Architectural Review Board Staff Report

Project Type:	Amended Site Development Plan
Meeting Date:	June 13, 2019
From:	Mike Knight, Planner
Location:	A 5.0 acre tract of land located south of Chesterfield Airport Road, east of Chesterfield Commons East Road and west of Baxter Road.
Description:	<u>Storage Masters Chesterfield Self Storage (ASDP)</u> : An Amended Site Development Plan, Landscape Plan, Lighting Plan, Architectural Elevations and Architect's Statement of Design for a 5.0 acre tract of land located south of Chesterfield Airport Road, east of Chesterfield Commons East Road and west of Baxter Road. (17T240188).

Architectural Review Board Submittal Package

Amended Site Development Plan for
STORAGE MASTERS
 16824 Chesterfield Airport Road
 Chesterfield, Missouri 63005

Figure 2: Color Site Plan

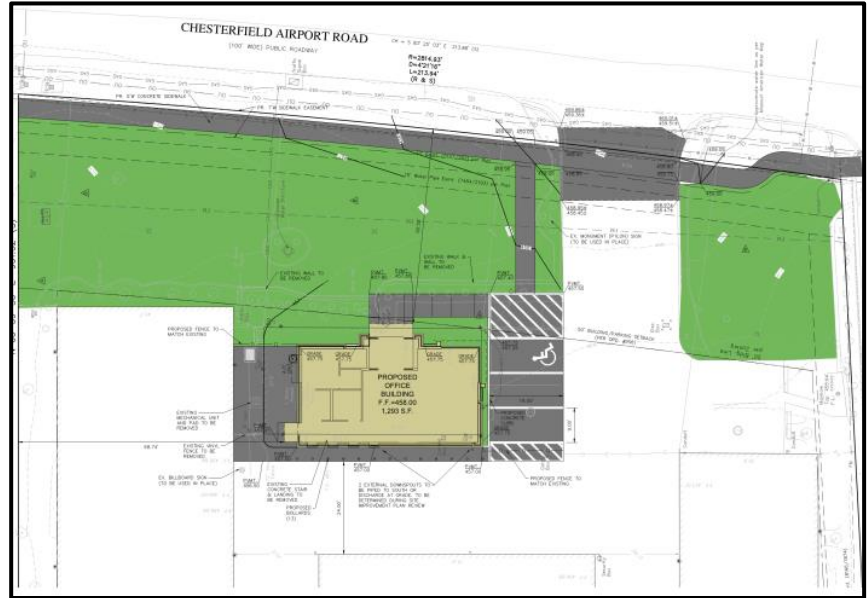
The scope of work is limited to a small portion of the site (Figure 2), along the frontage of Chesterfield Airport Road. The proposed structure is situated approximately in the same location as the existing structure with a slightly smaller footprint. The new appearance of the building enhances the compatibility with surrounding commercial developments within the Chesterfield Valley.

Figure 4: Existing Retaining Wall

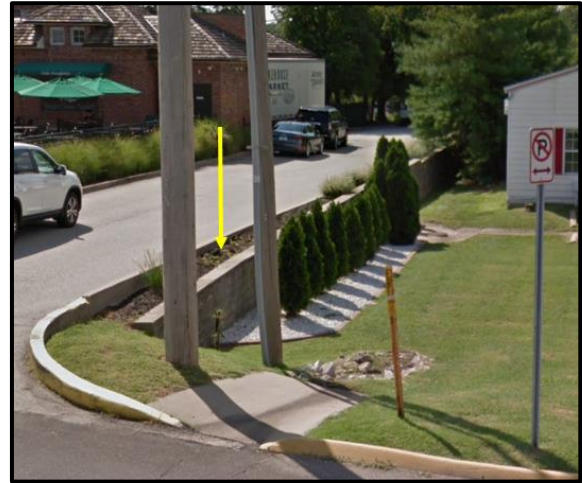
The subject site is relatively flat in nature. There are two retaining walls within the subject site. The first is a wall mediating the grade differential to the property to the east and scheduled to remain (Figure 4). The second is currently in front of the building scheduled to be removed and not replaced as it is no longer needed in function or design.

Sheet Title: Landscape Plan
 Sheet No: L-1
 Date: 4/11/19
 Job #: 584.031

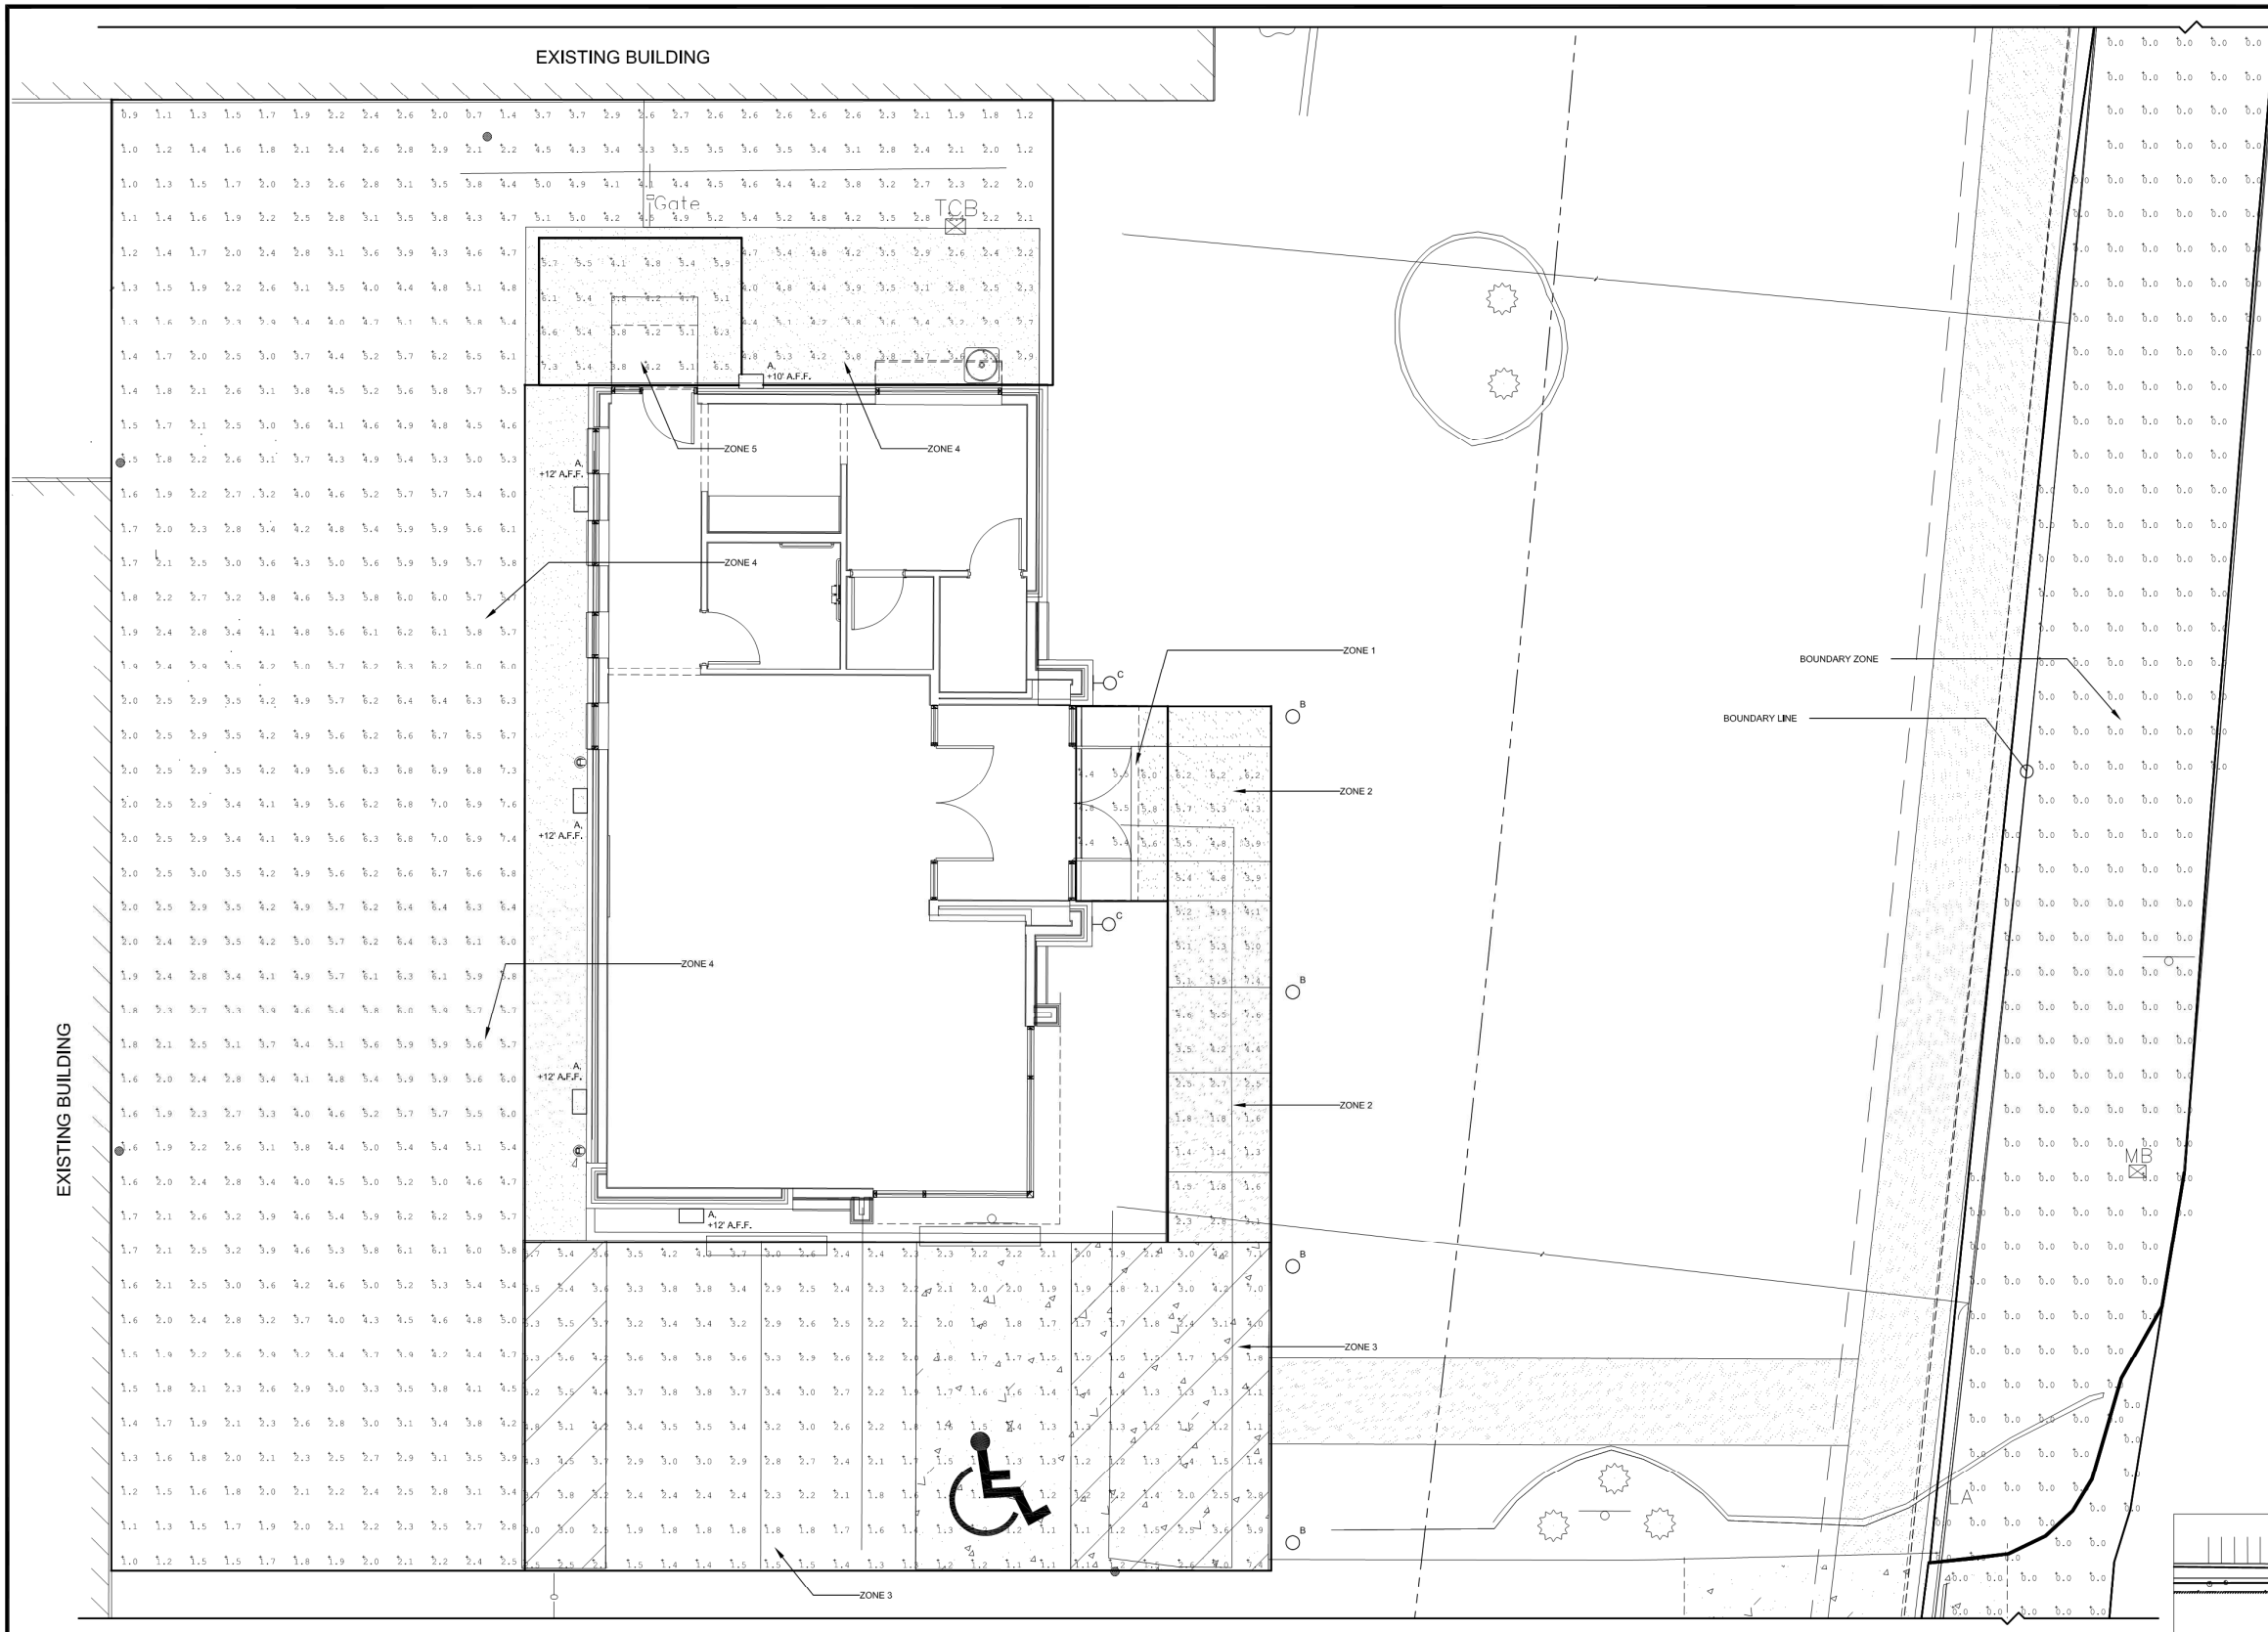
The required Landscape Plan has been submitted. A 30ft landscape buffer is required along all major arterials. The applicant has fulfilled this to the east and west of the building, but landscaping is lacking in the front of the building. Street trees are also required along the arterial roadway at 1 tree for every 50ft of frontage which are currently not seen on the plan. Proposed plantings include Juniper, Spruce, Redbud, and Maple.
